PLAN ENDORSED FOR IN-PRINCIPLE APPROVAL

Rev. 1	30-Aug-2021	For publishing on IPA website	AAB	ABK	HUR
No:	Date	Description	Drawn	Checked	Approved
ASTDS			80T BP TUG		
DESIGN NO: CT3380			TITLE		
			<b>GENERAL ARRANGEMENT</b>		
COCHIN SHIPYARD LIMITED		1:140	A2	CT3380	CT3380-101-001
P.O. Bag 1653, COCHIN-682015, INDIA		Scale	Format	Project No.	Dwg. no.

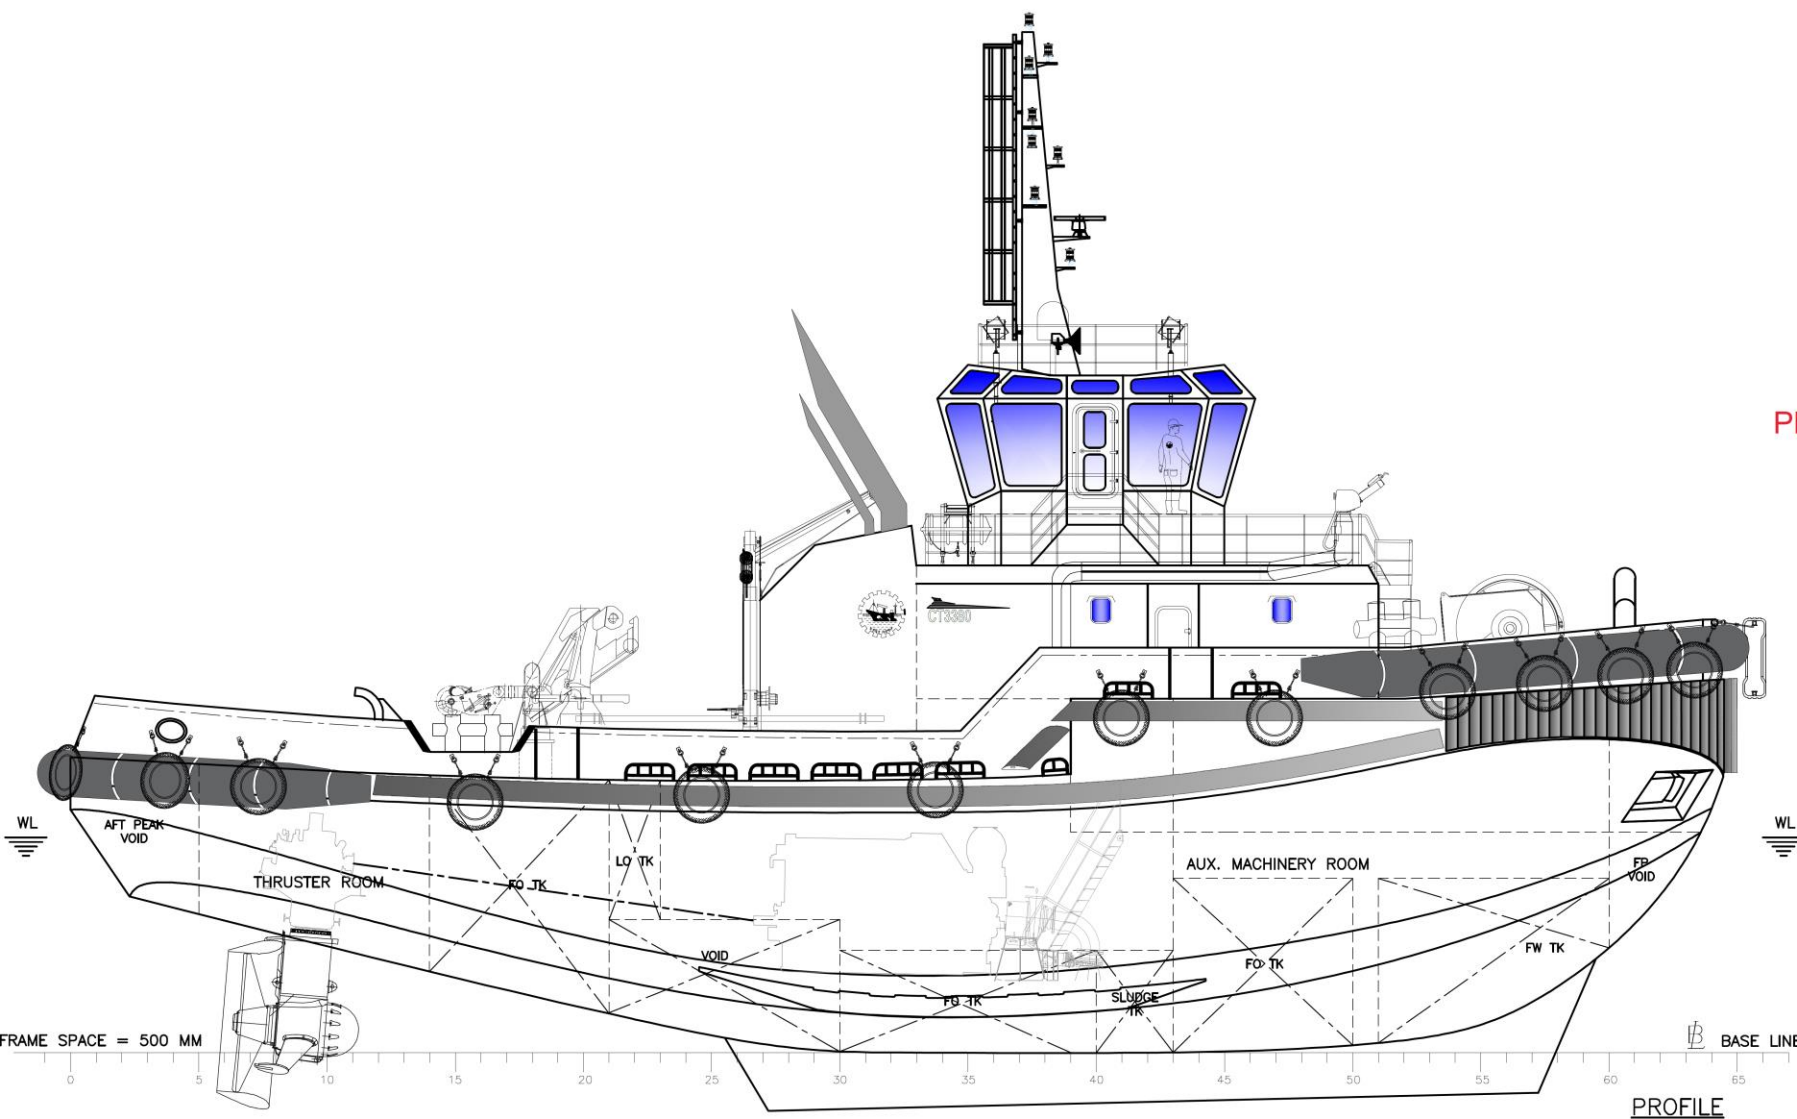
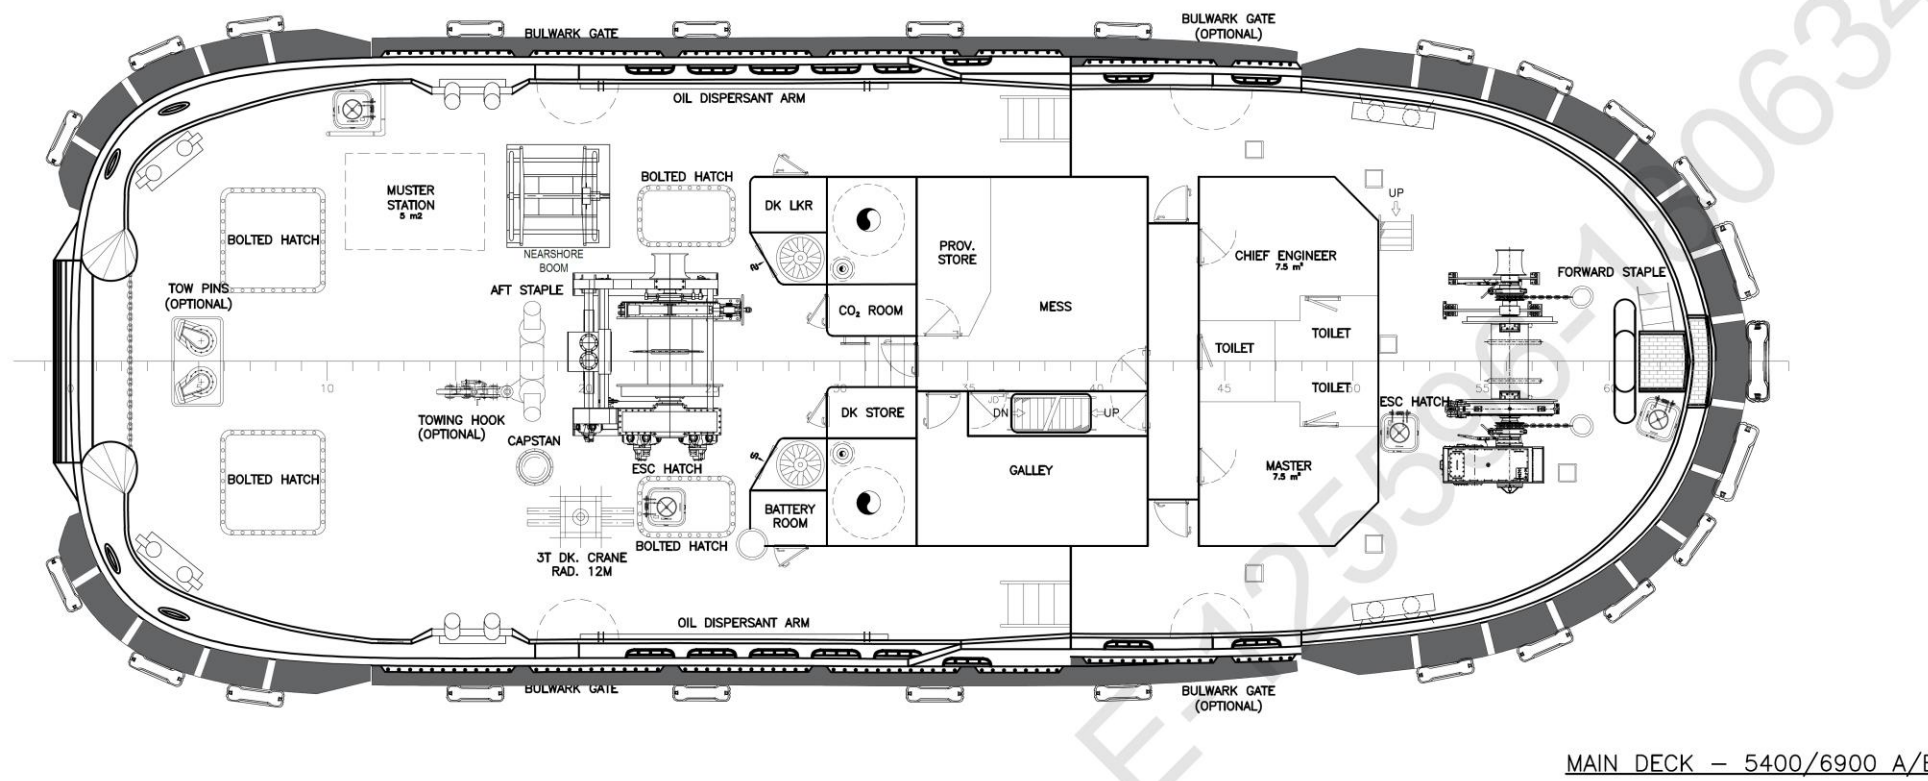
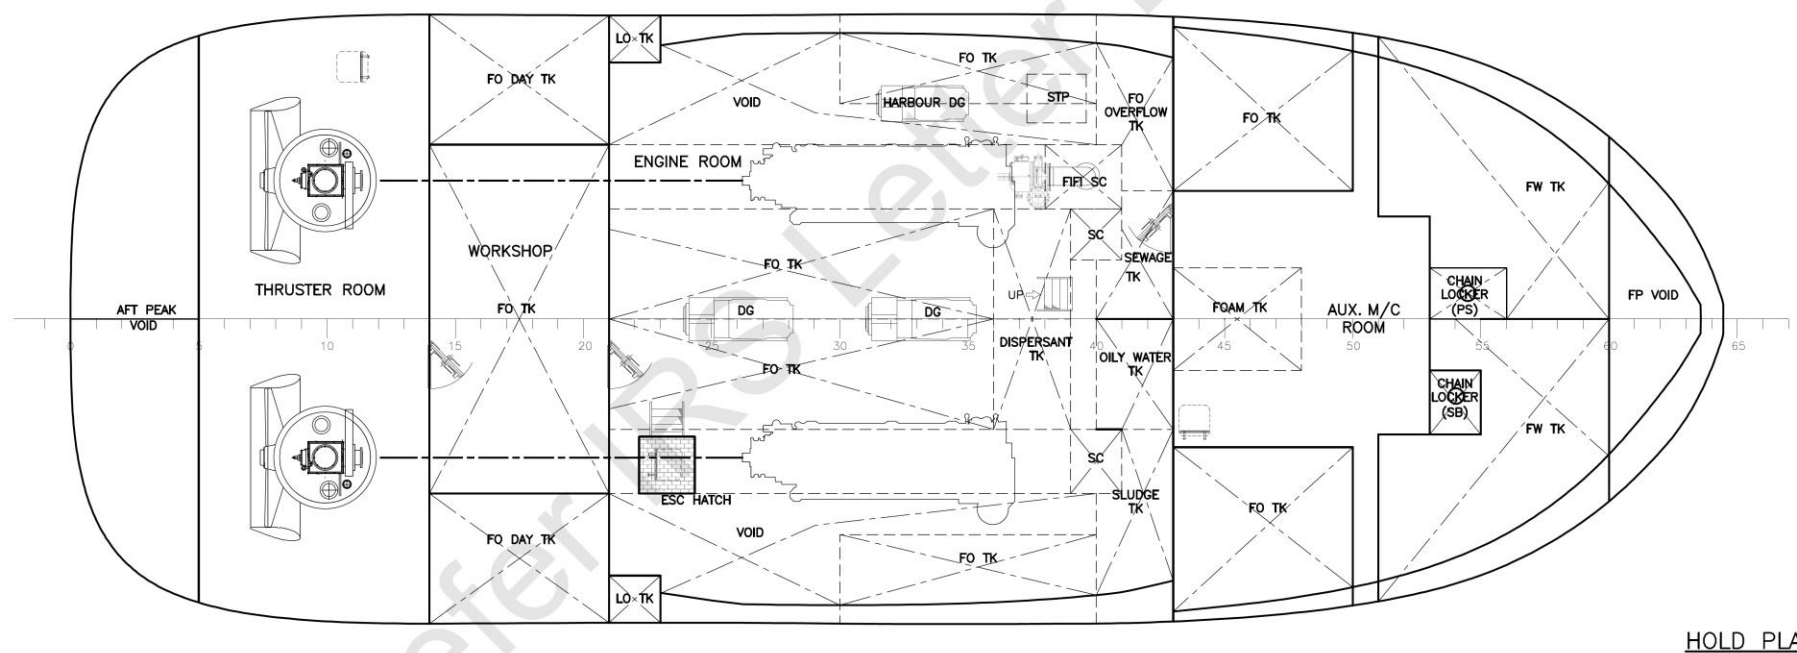
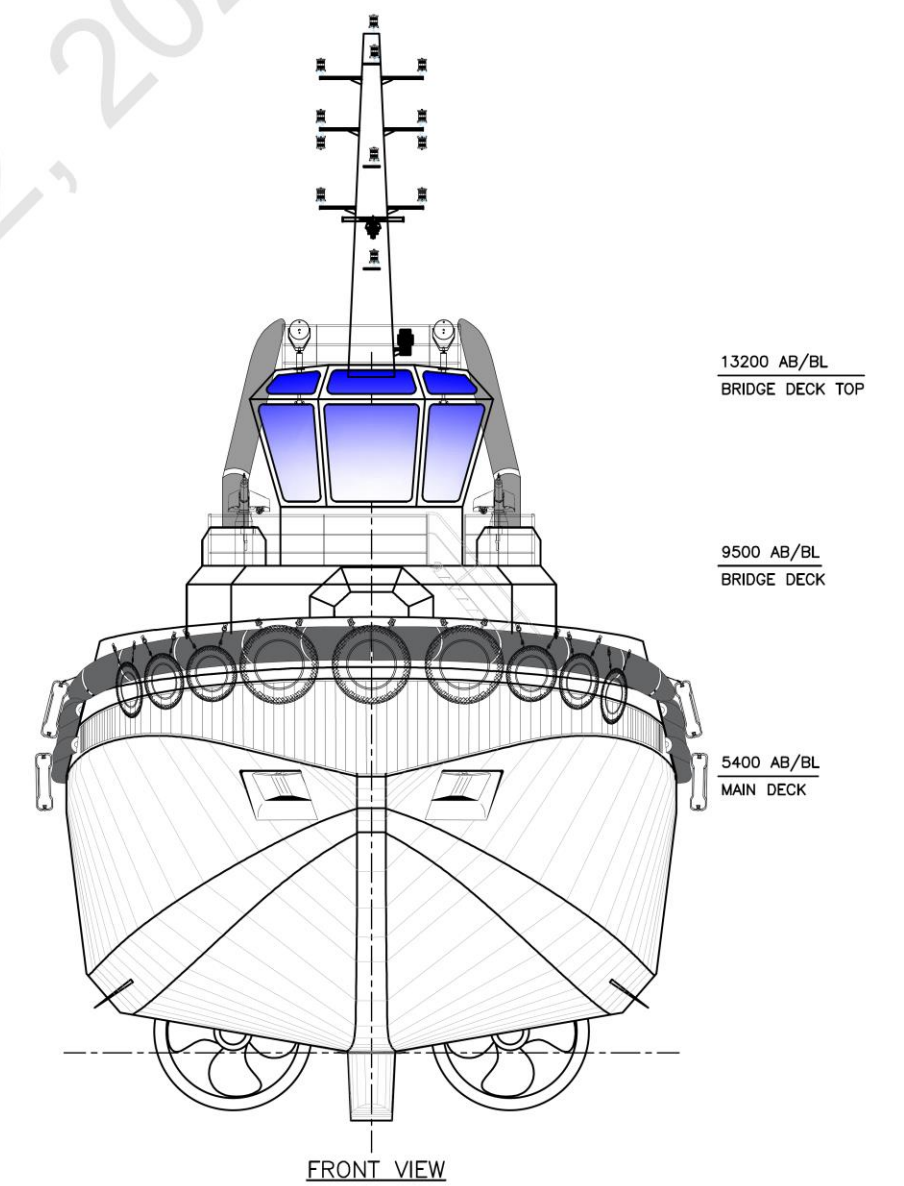
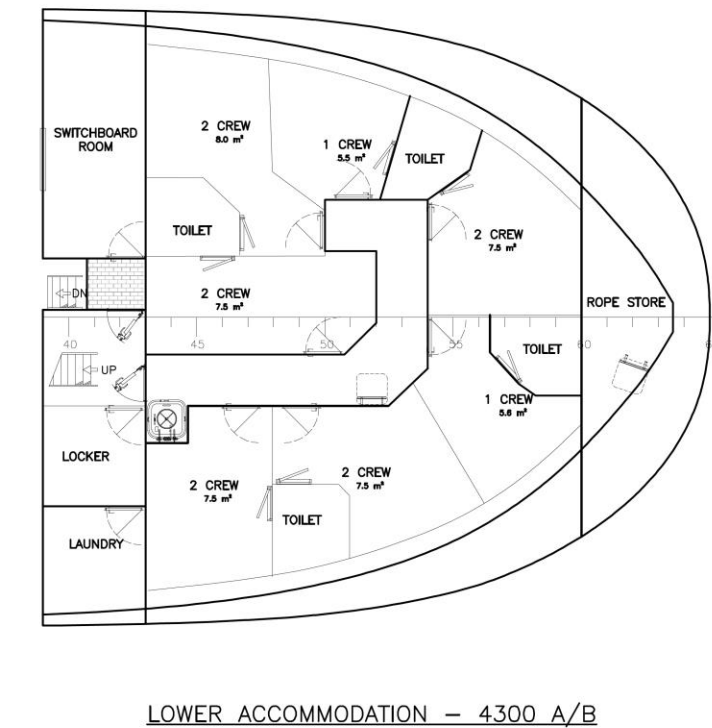
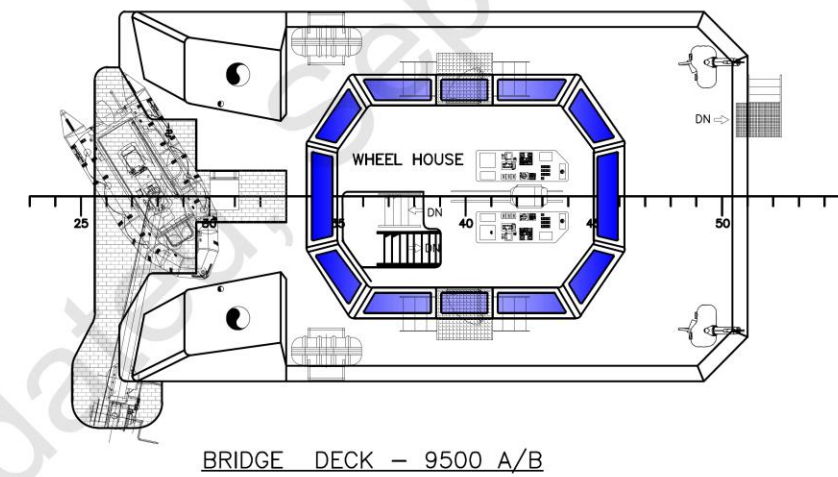
- Separate approval to be taken prior to construction for all applicable plans including LSA, LSS, Doors, Accommodation & Ventilation, Freeboard, bow height etc.

- Emergency source of power (batteries), associated transforming equipment, if any, transitional source of emergency power, emergency switchboard and emergency lighting switchboard are to be placed suitably (preferably inside a battery room) above main deck, aft of collision bulkhead.

- External FIFI system indicated in the GA corresponds to configuration 1 as per technical specification (Drw No : CT3380-100-006) & external FIFI system drawing (Drw No : CT3380-814-001). This configuration may be changed based on mutual agreement between the buyer & the builder . Separate class approval to be taken for external FIFI system in such cases.

- Full penetration weld to be provided in way of common boundaries of Foam Tank/ Dispersant Tank with any other tank.
- Height of ventilators to be in accordance with approved preim. stability report (Drw No : CT3380-101-009)
